Called Design Review Committee Meeting

DEPARTMENT OF PLANNING AND ZONING PLANNER'S REPORT

DATE: July 24, 2019
TO: Tonya Hutson
FROM: Michael Smith
VIA: Lynn Patterson
RE: **Design Inspection – 491 Walnut Street –**

DATE: June 29, 2019
TO: Tonya Hutson
FROM: Michael Smith
VIA: Lynn Patterson
RE: **Design Review – 3093 Hope Street Remodel**

FRONT ELEVATION "PROPOSED"
 SCALE: 3/16" = 1'-0"

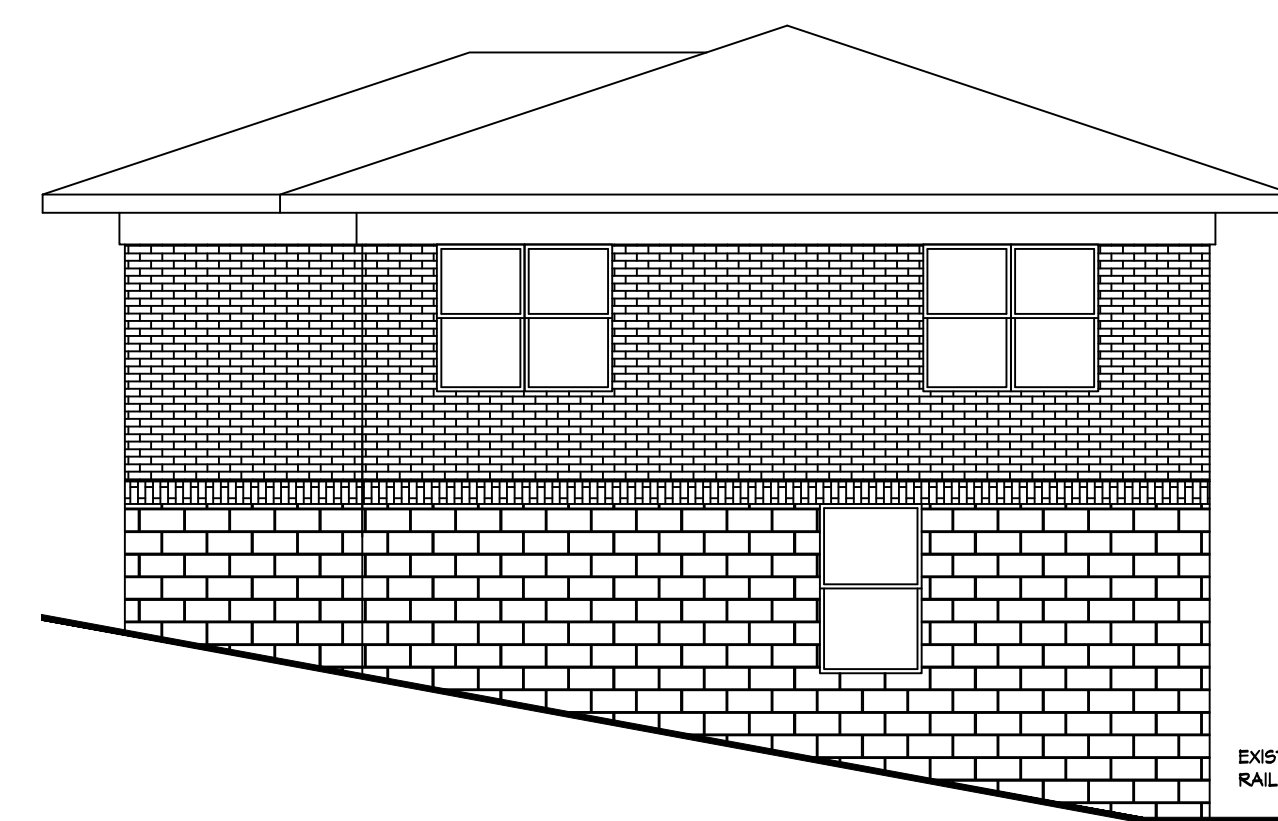
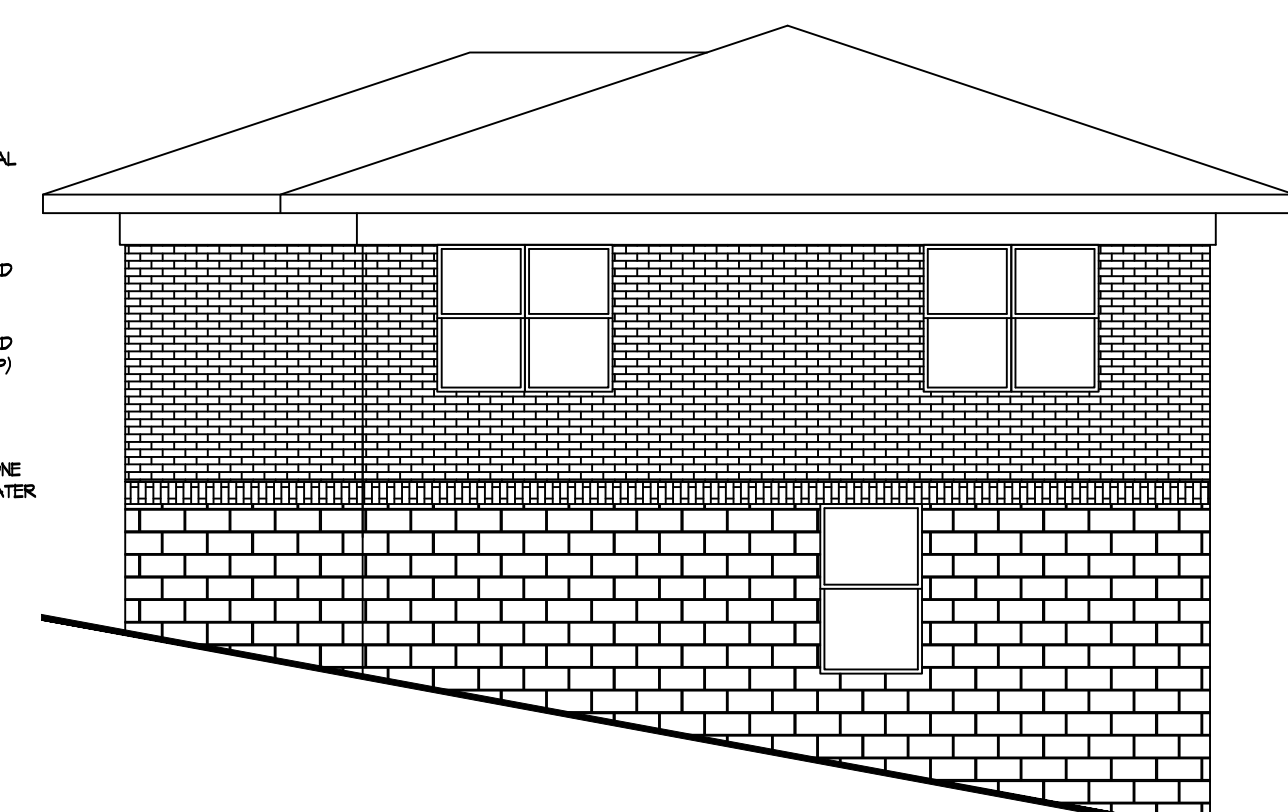
- **The Applicant is proposing a new stacked stone veneer for the foundation along the front façade. No other façade changes are within the scope of the project.**

The proposed changes to the existing structure detailed in the application meet the design requirements. The application is recommended for approval.
